## QUALITY ASSURANCE -- NON-CONFORMANCE REPORT

**Report No:** NCR-000632

**Reference Description:** ZPMC welder was observed welding outside of his qualified position on 6CW to 7AW Side Panel temporary attachments

**Job Name:** SAS Superstructure  
**Document No:** 05.03.06-000599

**Component:** Segment 6CW/7AW Side Panel

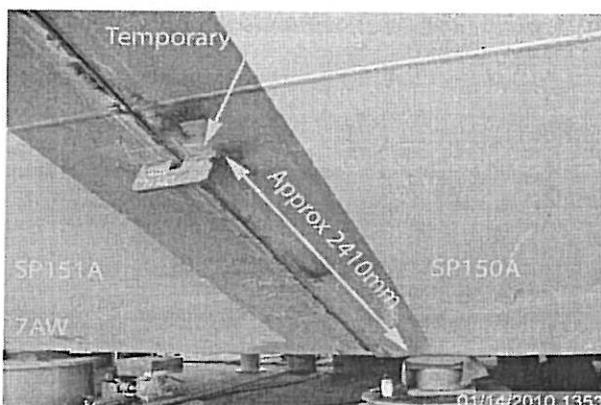
- Welder Xiao Di #203204 (2F) welding in the 4F position which he is not qualified.
- Welding was performed on temporary fit up plates SP150A (6CW) to SP151A (7AW) at the Side Plate Segment field splice, Counter Weight side.
- Fit up plate was welded approximately 2410mm from the Side Plate to Bottom plate splice weld.
- The material for 6CW SP150A (PL524A) is designated as Seismic Performance Critical Member (SPCM).
- The material for 7AW SP151A (PL527A) is designated as Non-Seismic Performance Critical Member (Non-SPCM).
- Segment 6CW/7AW is located outside in the Trial Assembly area.

AWS D1.5 (2002) Section 5.22.2.2 2F (horizontal) – “Qualification in the 2F (horizontal) position shall qualify for flat and horizontal position fillet welding of plate and structural shapes”.

Contractor submitted documentation verifying that a Caltrans QA Inspector witnessed Mr. Xiao Di, welder ID No. 203204, perform Welder Qualification Testing on 03-09-2010 in the overhead position. The welder demonstrated his ability to weld in said position and is now qualified.

**Component:** 6CW counterweight connection plate

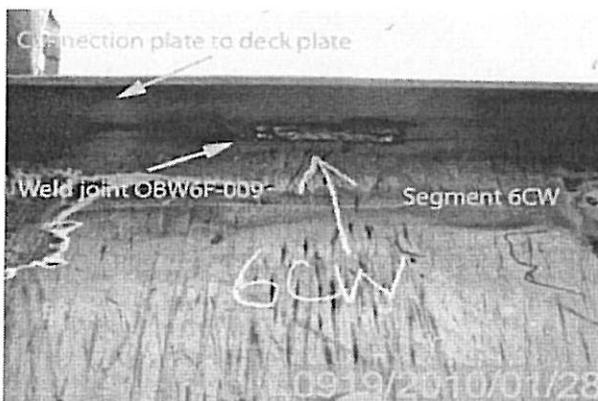
- ZPMC welder Xiao Di # 066401 was observed welding in the 4F overhead welding position, which he is only qualified in 3F vertical position.
- Welding was performed on the Connection Plate to Deck Plate.
- The Deck Plate is identified as CA29A.
- The weld is identified as OBW6F-009.
- This weld is a Complete Joint Penetration (CJP).
- A total of eight (8) repairs were performed on the bottom side of weld joint OBW6F-009.
- These repairs are located on the Counter Weight side of segment 6CW at the W3 line.
- Lift 6W is located in the OGB Trial Assembly Area.

AWS D1.5 (2002) 5.22.2.3; 3F (Vertical). Qualification in the 3F (vertical) position shall qualify for flat, horizontal, and vertical position fillet welding of plate and structural shapes.
